Access Compliance Report

Public Rights-of-Way

(Curb Ramps)

Intersection ID: 15217	Main Street: ALBEMARLE_RD	Cross Street: WINTERHAVEN_DR	Location: NW
ADA ID: 7E8FED18AD12	Ramp Type: Perp	Initial Pass/Fail: Fail	Overall Compliance: No
Severity Score: 22.5			
Codes/Mitigation Info/Possible Solution		Field Measurements/Component Compliance

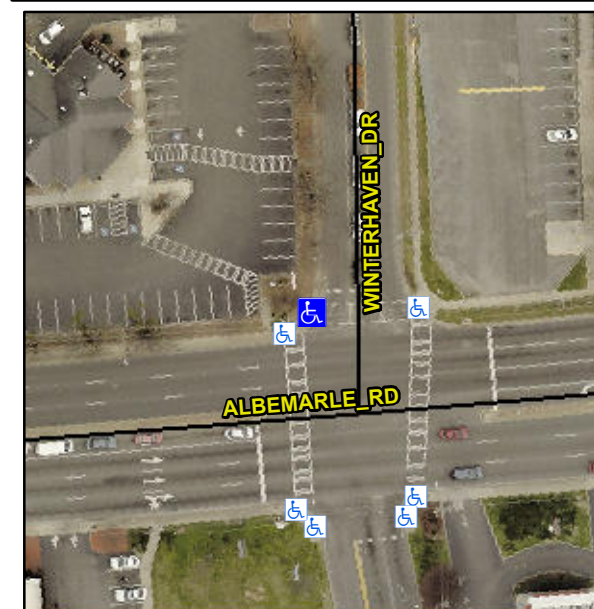
Not Found, R304.5.1, R304.2.2, R304.5.3

Compliance	Description	Data	Compliance	Description	Data
N/A	Ramp Length (in)	60.0	No	Ramp Slope (%)	10.0
No	Ramp Width (in)	43.0	No	Ramp XSlope (%)	4.7
N/A	Flare Type LT	N/A	N/A	Flare Type RT	N/A
N/A	Flare Slope LT (%)	N/A	N/A	Flare Slope RT (%)	N/A
N/A	Flare Traversable LT?	N/A	N/A	Flare Traversable RT?	N/A
N/A	Landing Length (in)	N/A	N/A	DWS Provided?	N/A
N/A	Landing Width (in)	N/A	N/A	DWS Contrast?	N/A
N/A	Landing Slope (%)	N/A	N/A	DWS Length (in)	N/A
N/A	Landing X Slope (%)	N/A	N/A	DWS Full Width?	N/A
N/A	Landing Curb? (Y/N)	N/A	N/A	DWS Offset (in)	N/A
N/A	Shared Landing?	N/A			
N/A	Gutter Ponding?	N/A	N/A	Gutter Slope (%)	N/A
N/A	Gutter Lip Ht (in)	N/A	N/A	Gutter X Slope (%)	N/A
N/A	Painted X Walk1?	Yes	N/A	Painted X Walk2?	N/A
	X Walk 1 Direction	To E		X Walk 2 Direction	N/A
N/A	X Walk 1 Width (in)	114.0	N/A	X Walk 2 Width (in)	N/A
	X Walk 1 Slope (%)	3.7		X Walk 2 Slope (%)	N/A
	X Walk 1 X Slope (%)	3.4		X Walk 2 X Slope (%)	N/A

Remove & Replace Entire Ramp.
